RE: RESPONSE TO DÚN LAOGHAIRE-RATHDOWN COUNTY COUNCIL'S LRD OPINION AND ADDITIONAL INFORMATION REQUIRED, DATED 13TH JULY 2022, IN RELATION TO PROPOSED LARGE-SCALE RESIDENTIAL DEVELOPMENT AT DALGUISE HOUSE, MONKSTOWN, A94 D7D1

DLR Ref. PAC/LRD2/006/22

Figure 2.1.1: Mix of Uses across the site, including location of potential Build to Sell units, Active Living, Part V, Residential Amenities. (Source: RAU Design Statement, 2022.)

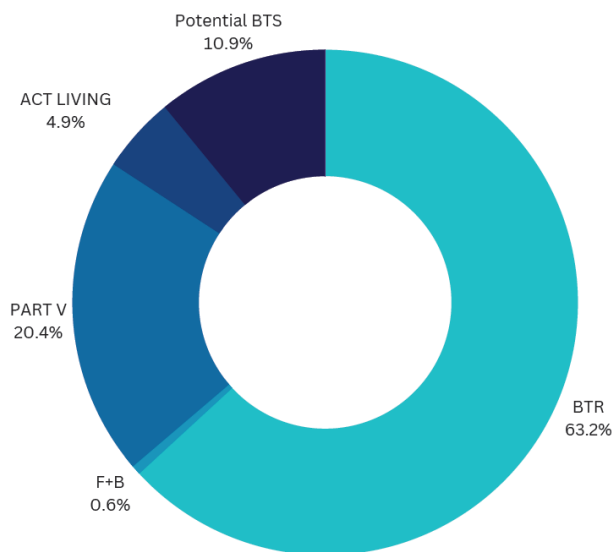
'The applicant is requested to address potential issues and concerns regarding density/design/unit mix/ and layout, and proximity to boundaries.

The report should include details that address potential issues and concerns regarding ownership/tenure, and dwelling size/ mix quantum, and demonstrate if the proposed provision (as a BTR scheme only) is the optimum solution for the site and location.

As detailed in the enclosed Architects *Design Statement* the proposed units provide for a mix of dwelling needs and there is also provision made for future adaptability. Blocks I1 and I2 are designed to accommodate the need of elderly residents under the Active Living category. Greystar operates a senior housing portfolio of over 20,000 units and Blocks I1 and I2 have been designed to take these requirements into account. These 3 storey Blocks, of 12 No. units each, are attractively positioned in a to the rear of the site between the rear boundary wall and the Walled Garden. Surface Level car parking is available nearby for less mobile residents who require it and communal open space with mature trees are to the rear of the buildings providing a secure and private location.

The existing buildings that are to be retrofitted and restored in the proposed development provide 7 No. units, which are not subject to the standards set out in the Apartment Guidelines, and could therefore be used as build to sell units in future. The units in Block H have been designed to comply with Build To Sell standards (subject to the provision of additional balconies). That Block is also future proofed in terms of the design such that smaller units can be combined to increase the number of larger units in future, subject to any necessary consents. This allows future flexibility in the use of the apartments to cater for potential changes in demographics.

Furthermore, the scheme will provide Part V units, thereby catering to another tenure on the site, and providing much needed social and affordable housing in the Monkstown area.
